2010 Annual Geotechnical Inspection, Boston Advanced Exploration Project

Hope Bay, Nunavut

Project Reference Number
SRK 1CH008.032

February 2011

Engineers and Scientists VANCOUVER	 NORTH AMERICA	2010 Geotechnical Inspection		
		Boston Thermistor Conditions		
Job No: 1CH008.032	HOPE BAY MINING LTD.	Date: February 2011	Approved: EMR	Figure: 5
Filename: Figure 5_BostonThermistor_20110216.pptx

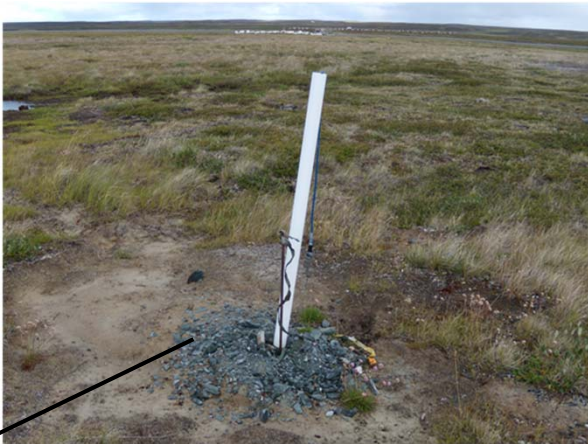
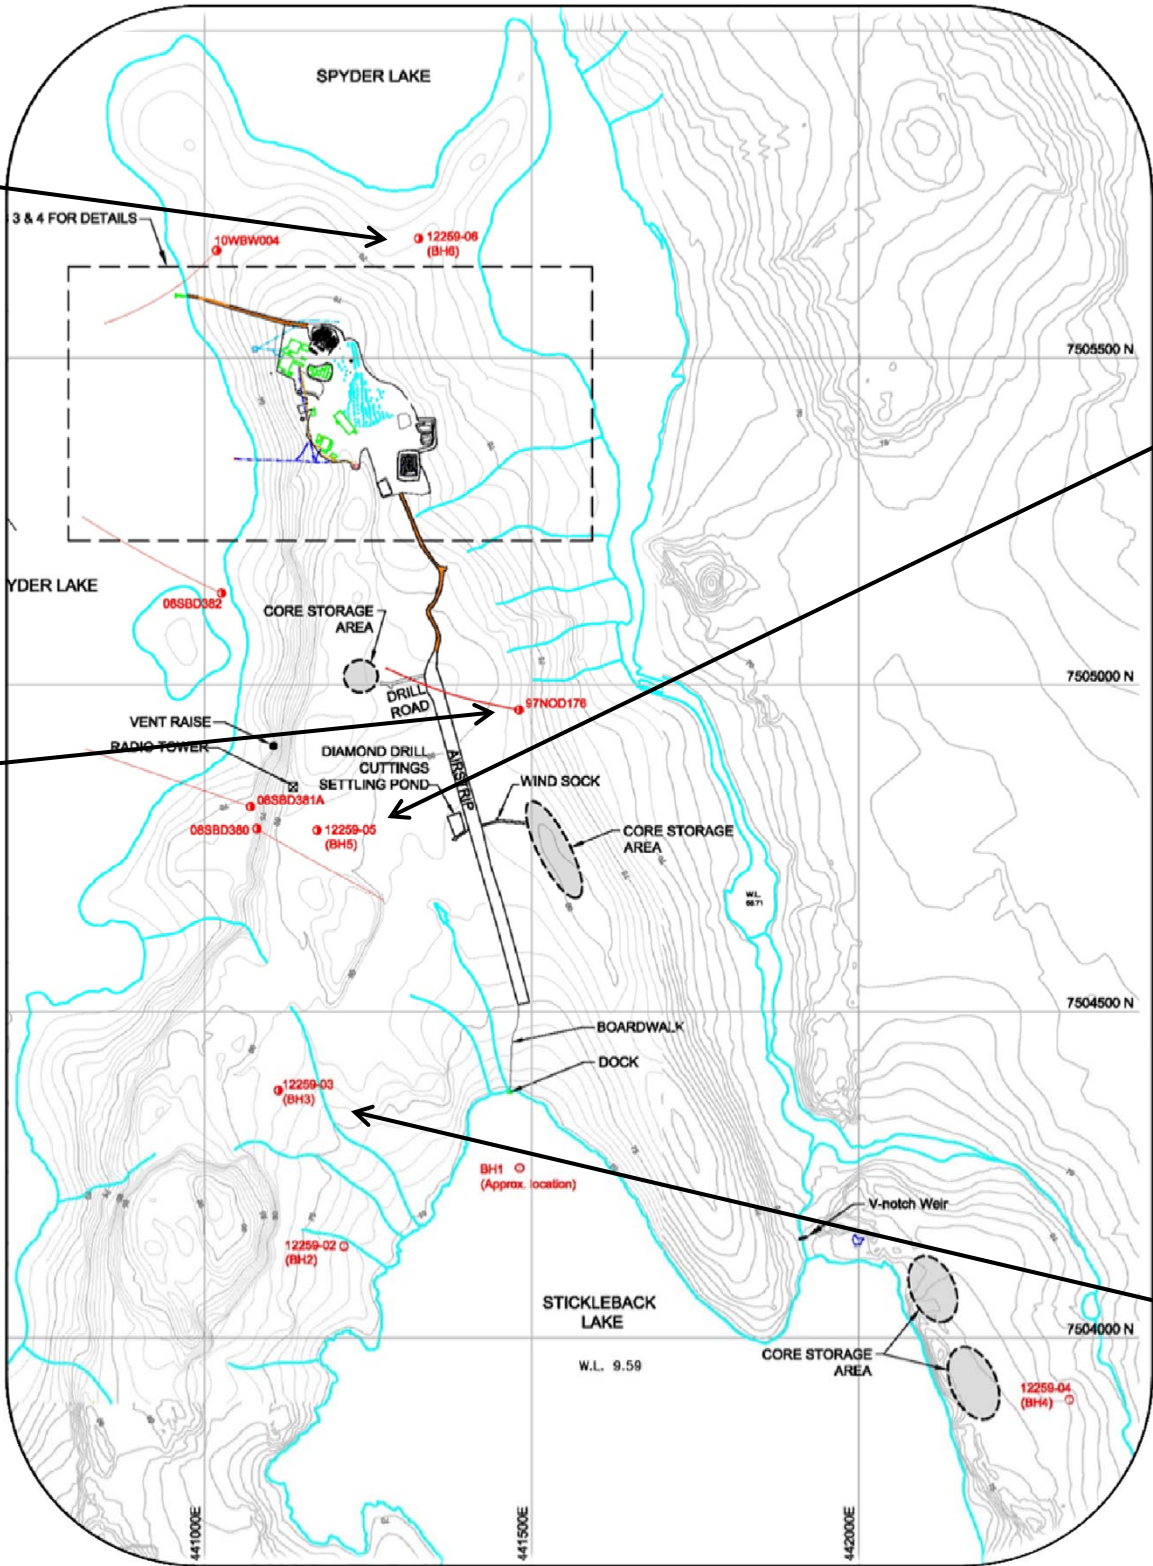
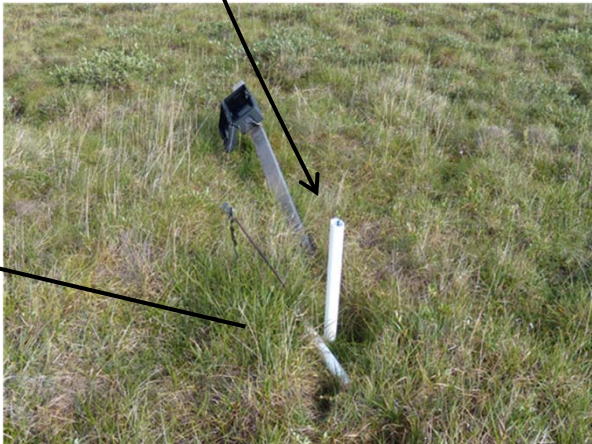
determine their status. One string was severed completely (drill hole 12259-03, see Figure 5), but the remaining three appear to be intact. A readout device compatible with the military connectors on the strings was not available to test the functionality of these strings. An appropriate readout device should be obtained from EBA Engineering (the original thermistor supplier) and the string functionality should be tested during the 2011 geotechnical inspection. If the three in-tact strings are functional, the fourth string should be spliced and tested as well.

A summary of the available site thermistors are discussed in Section 2.5 and all available data are presented graphically in Figures 6 through 13. With the help of HBML surveyors, the 1996 and 1997 thermistor strings were located in 2009. Three of the four strings were still intact, although they are generally in poor condition, having fallen over from their support struts. Figure 5 illustrate their current state. The fourth cable has been completely severed, most likely by an animal. The section of cable to which the readout connector is attached, is still at the site, and it should be possible to re-attach the cable through splicing.

Job No: 1CH008.032
Filename: Figure 14_BostonTankFarm_20110216.pptx

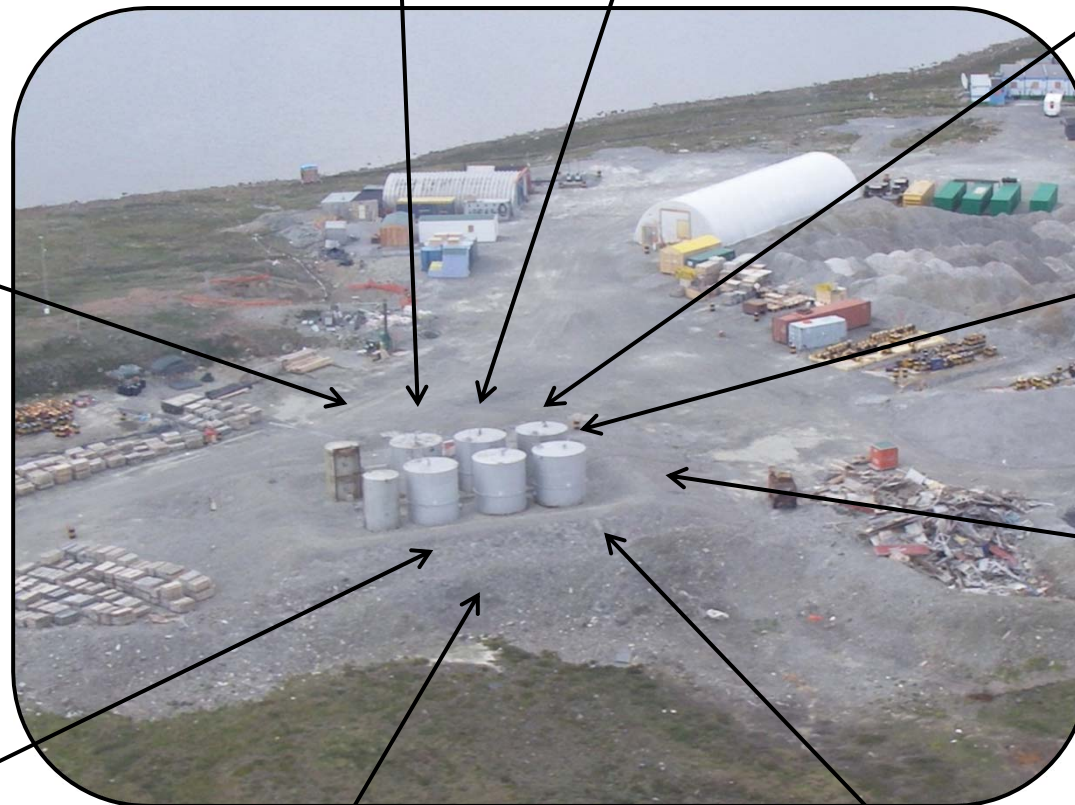
The primary tank farm, housing eight large fuel tanks is located in an engineered secondary containment facility constructed in 2001 (Figure 14). SRK understands that there is no formal as-built documentation for the facility. Based on interviews, SRK concluded that the facility was designed by EBA and subsequently constructed by MHL with engineering supervision by EBA.

2. The tank settlement monitoring program that has been put in place is reasonable. Quarterly monitoring (or as close to this schedule as the camp operating window allows) of tank settlement should continue. This data should be reviewed and reported on as part of the annual geotechnical inspection and, should there be any signs of undue movement appropriate mitigation plans should be put in motion.

Workshop and Crusher Area

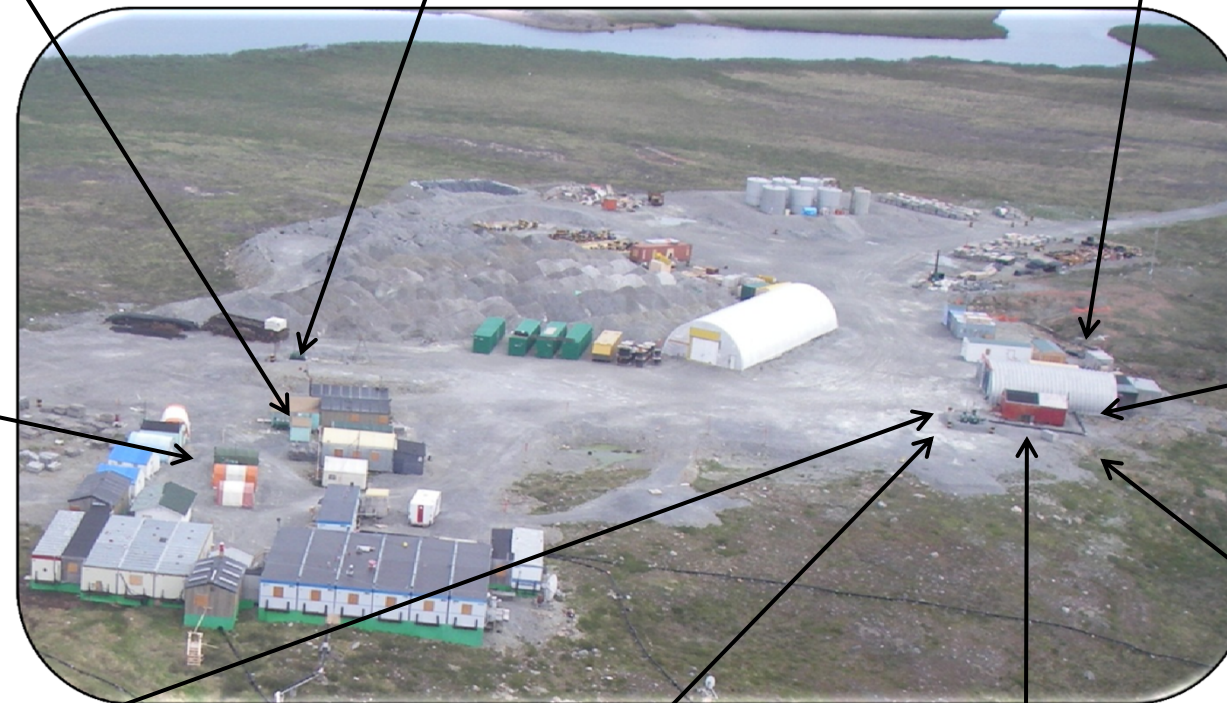
Two new fuel tanks were observed during the 2010 inspection within the confines of the camp (Figure 15). These are elevated double-walled tanks. Neither of the tanks were however placed within secondary containment as per the normal HBML protocol.

Fuel tank without secondary containment.

Job No: 1CH008.032
Filename: Figure 17_ BurnPit_Pond_ 20110216.pptx

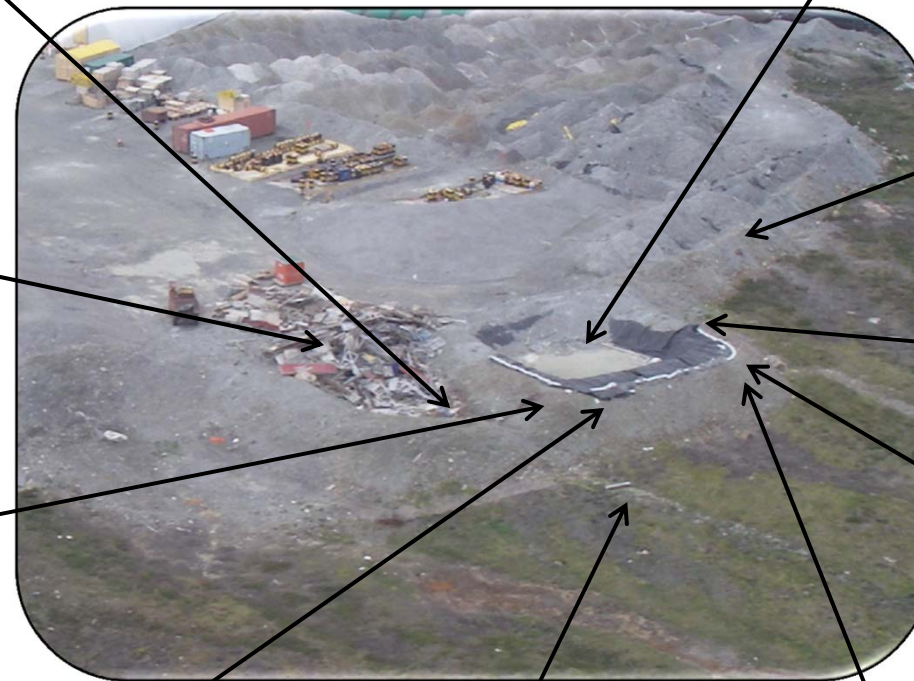
At one time, all wood waste was burned in a burn pit (a converted sedimentation pond) located immediately south of the active sedimentation pond (Figure 17); however, this practice has been discontinued and all non-combustible materials was removed from the pit. The burn pit itself is still used to contain unburned wood waste and ash, until such time as HBML backhauls these materials, or adopts an alternate strategy to dispose of these elements.

One lined settling pond (Figure 17) has been constructed along the eastern perimeter of the camp foundation pad (immediately north of the burn pit). As-built records for the construction of this pond are not available. It is understood that this pond was used to contain wash water during the screening and crushing of ore as part of the bulk sampling program.

Currently the pond is used as an emergency holding pond for possible fuel spills, disposal of water from fuel containment berms, or when the sewage treatment plant experiences upset conditions. SRK is of the opinion that, if this pond is to be used for anything where there would be solids collected in the pond, its design would make it extremely difficult to remove these solids to retain

1. Water quality sampling should be undertaken to confirm whether the wet zone downstream of the pond is in fact seepage emanating from the pond. If the flow is confirmed as seepage, an appropriate mitigation plan must be implemented to have the liner repaired.

2. The debris in the pond should be cleared out as it poses a potential puncture risk to the liner.
3. A management plan must be implemented to ensure sediment (i.e. hydrocarbon contaminated soil, sewage treatment plant sludge, etc.) can be removed without damaging the liner.

Job No: 1CH008.032
Filename: Figure 20_Portal_ncineratorArea _ 20110216.pptx

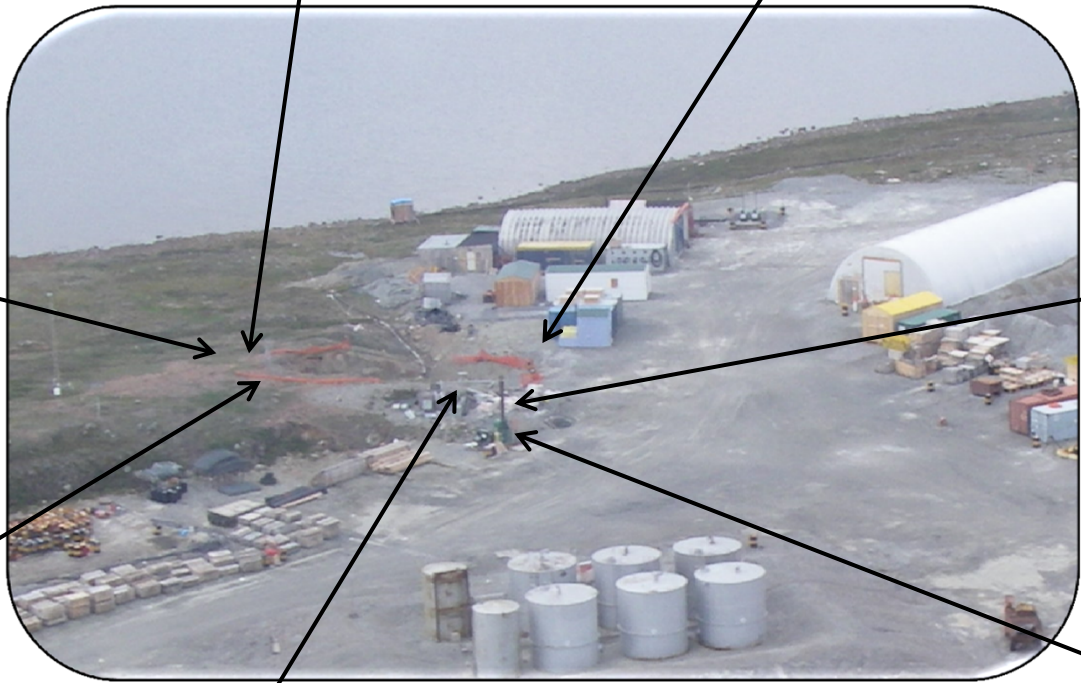
The portal, which is located about 25 m east of the maintenance shop as illustrated in Figure 20, was collared in altered volcanic rock, all within the permafrost. This was confirmed through installation of four underground thermistors (Golder 2000a, b). During extraction of the bulk sample, the portal was not heated but operated at an ambient temperature of about -10°C. The portal was operated under dry conditions with no groundwater inflow. After completion of the bulk sample collection, the portal was abandoned and sealed off with a locked gate.

1. SRK recommends that HBML replace the weathered warning notices at the portal entrance advising of the dangers associated with unauthorized access to the area.
2. The rock spalling on the exposed section of the portal roof is likely a fall hazard. Persons entering the area should wear appropriate personal protective equipment; however, a site specific hazard assessment should be completed to make people aware of the dangers. Should there be a need for any individual to enter the area for reasons other than a brief inspection, consideration should be given to installing roof support, such as a small diameter wire mesh (50 mm mesh) to mitigate the fall hazard.

Airstrip

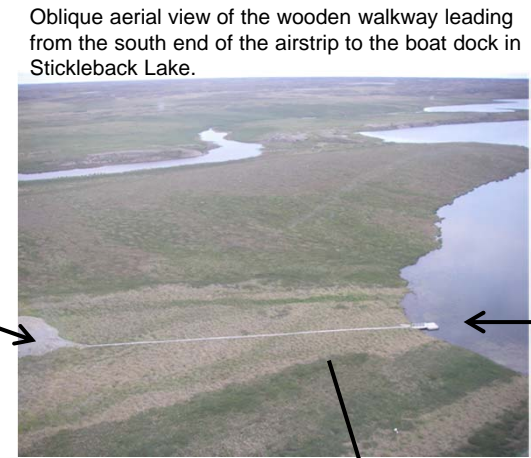
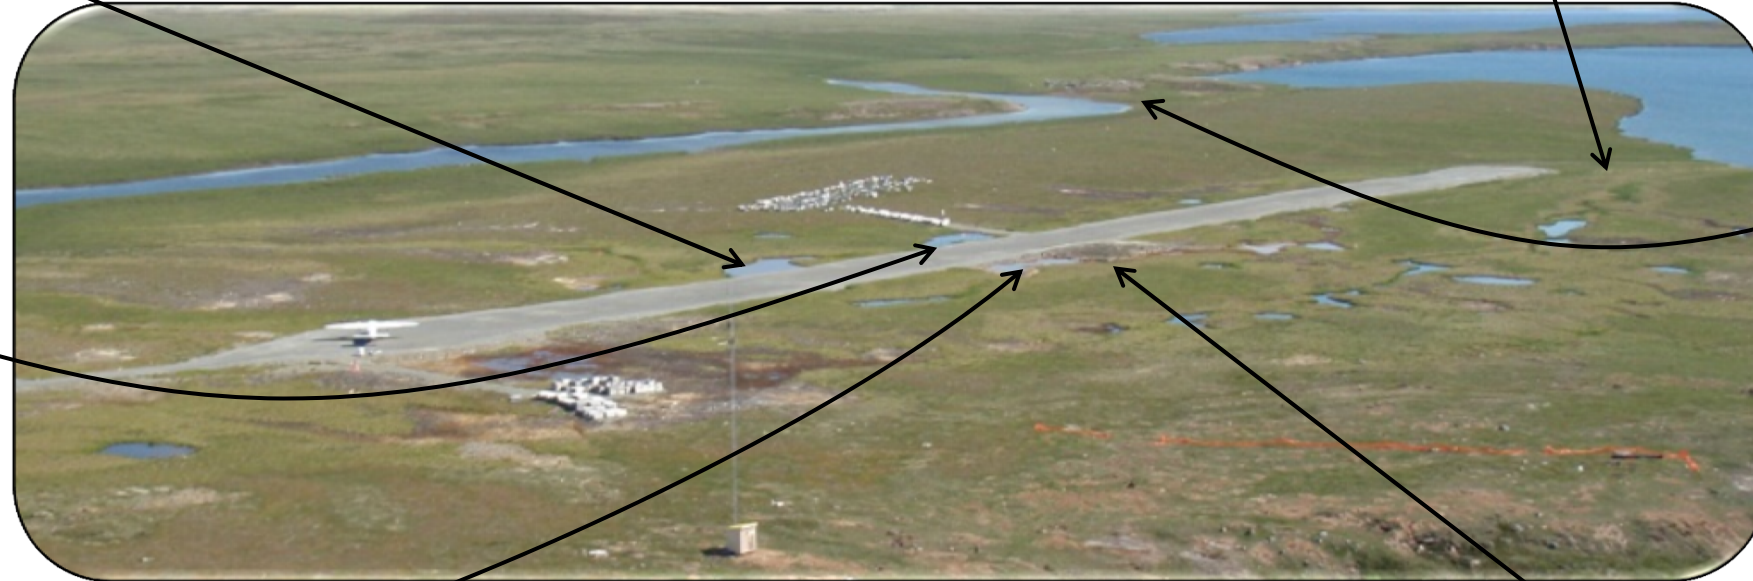
The wooden walkway leading from the southern end of the airstrip to a boat dock in Stickleback Lake (Figure 22) has been constructed as a floating walkway directly on the tundra. The walkway has settled into the tundra hummocks and although there is no lasting permafrost damage at this time, vegetation dieback may ultimately result in the start of an erosion gully, which in turn would lead to erosion permafrost degradation.

1. Consideration should be given to reconstructing the walkway such that it does not rest directly on the tundra. If this is not practical given the use the walkway gets, a monitoring program should be implemented during the summer months to ensure that erosion gullies do not go unnoticed.
2. If the boat dock is decommissioned, remove the walkway.

A V-notch weir was installed at the outlet from Stickleback Lake in the early 1990's as part of baseline data gathering studies (Figure 22). The installation was done with the least amount of invasive techniques, by wedging in the measurement weir using tote bags filled with drill cuttings. In accordance with the Water Licence, this weir should be removed. A detailed inspection of the conditions at this weir was not completed during the 2010 inspection.

1. Complete a thorough inspection of the conditions at the V-notch weir during the 2011 annual geotechnical inspection.
2. Develop an appropriate remediation plan for removal of the V-notch weir.

Permafrost degradation pond along east shoulder of airstrip

Tension cracks along crest of airstrip in areas where ponding exist,

Job No: 1CH008.032
 Filename: Figure 24_CoreStorage_20110216.pptx

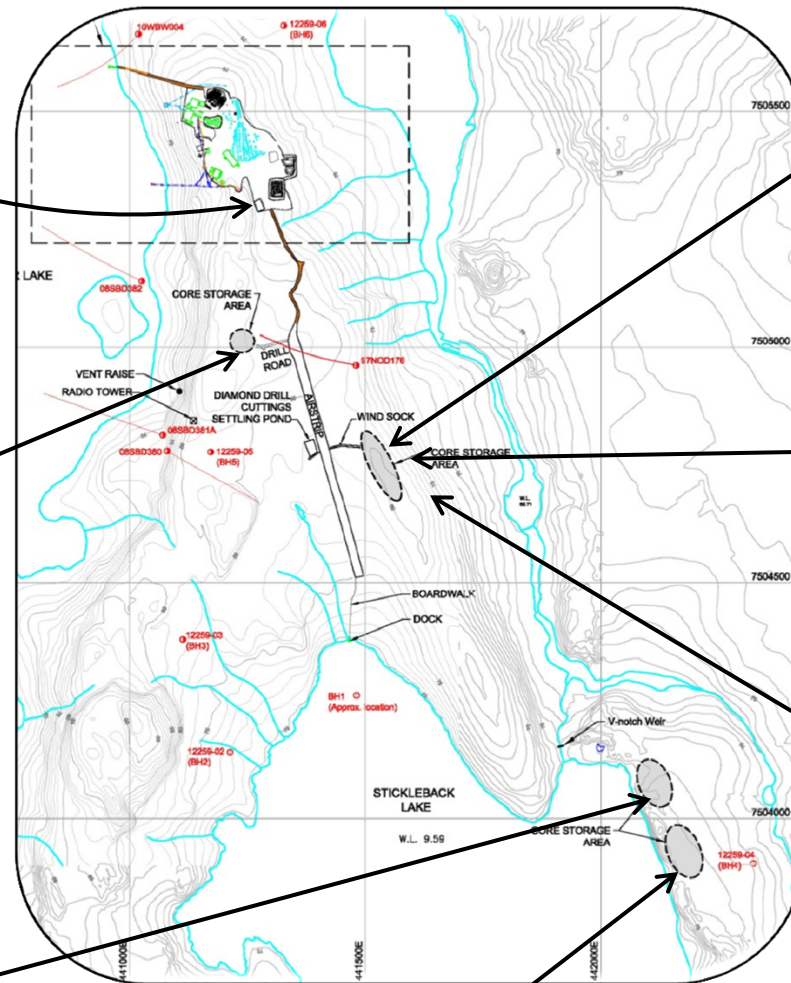
Core boxes are being stored at the following locations, as illustrated in Figure 24:

1. HBML should re-evaluate their core storage requirements, as the random aerial spread of core boxes at these locations may not be suitable in the long term.
2. Consideration should also be given to relocating any core storage boxes that are not currently on exposed bedrock. This should be done as part of a long-term core storage plan.
3. HBML should consult the services of an expert knowledgeable with tundra vegetation to implement appropriate remediation strategies.

Date: February 2011	Approved: EMR	Figure: 25
------------------------	------------------	---------------

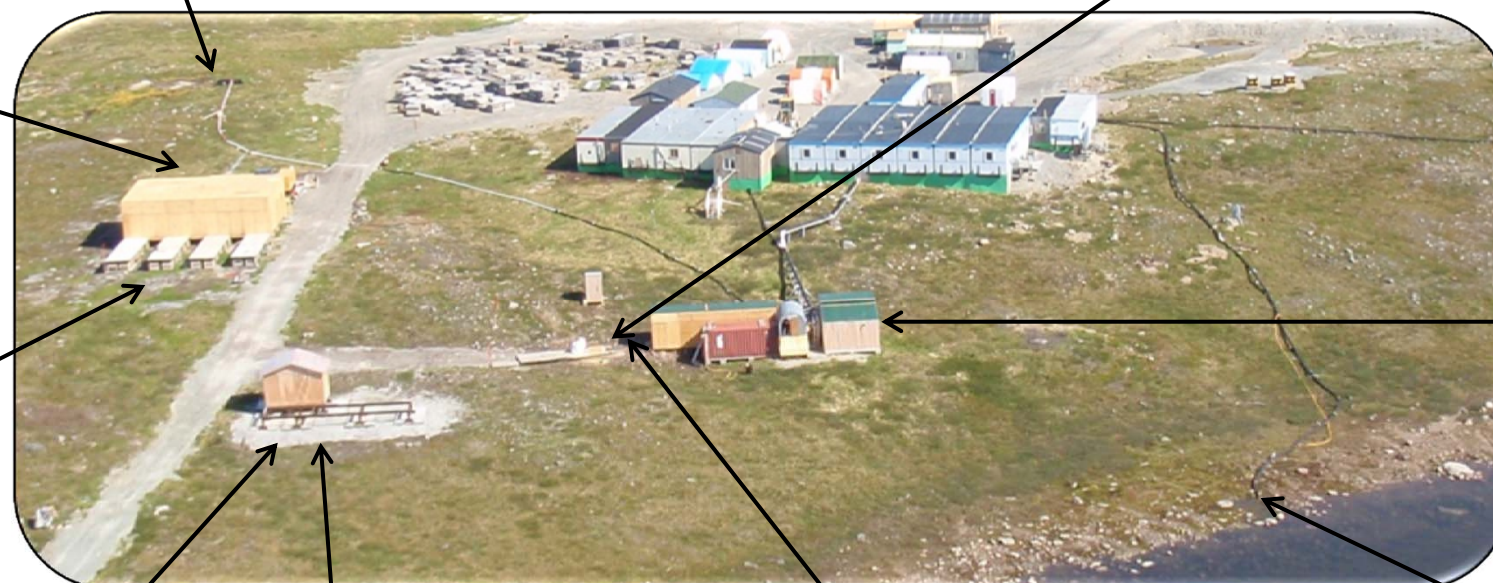
The existing sewage treatment plant (STP) is constructed on a small levelling pad of crushed ore, some distance west of the camp pad (Figure 25). The pad is generally very thin, (less than 0.5 m thick) and therefore not sufficiently thick to act as a true thermal pad. There are however no signs of permafrost damage at this time.

The new sewage treatment plant (STP) will be constructed north-west of the camp, and north of the existing STP (Figure 25). Originally this STP was to be constructed on a levelled thermal pad constructed from crushed ore; however, in accordance with the newly adopted water and ore/waste rock management plan for the site (SRK 2009d), HBML changed the design. The pads were however already constructed before the decision to change was made and therefore the ore had to be backhauled. One of the two constructed pads was however not removed. Where the pad was removed some minor damage to the tundra vegetation occurred, which could result in ongoing permafrost degradation if not monitored and repaired if and when it becomes evident.

Grey water from the sewage treatment plant is currently being discharged at a location immediately north of the camp foundation fill pad (Figure 25). This water ultimately flows overland towards the east arm of Stickleback Lake. During the 2007 inspection it was noted that a large clearing devoid of any vegetation has developed where the water is discharged, and although there was no standing water at the time of the inspection, it is evident that at times significant ponding did exist. A well developed overland channel has also formed where the ponds overflow onto the tundra, and since the vegetation in this area no longer exists, there are signs of overland erosion.

1. SRK understands that HBML has developed a new sewage management plan (SRK 2009c), which will be implemented to coincide with commissioning of the new STP. Grey water discharge should be in accordance with this new plan.
2. The erosion protection measures currently in effect is an improvement over what was in place in 2007; however, a long-term plan is required as prolonged application of grey water in the same area will not be managed through erosion protection measures alone.
3. HBML should consult the services of an expert knowledgeable with tundra vegetation to implement appropriate remediation strategies.
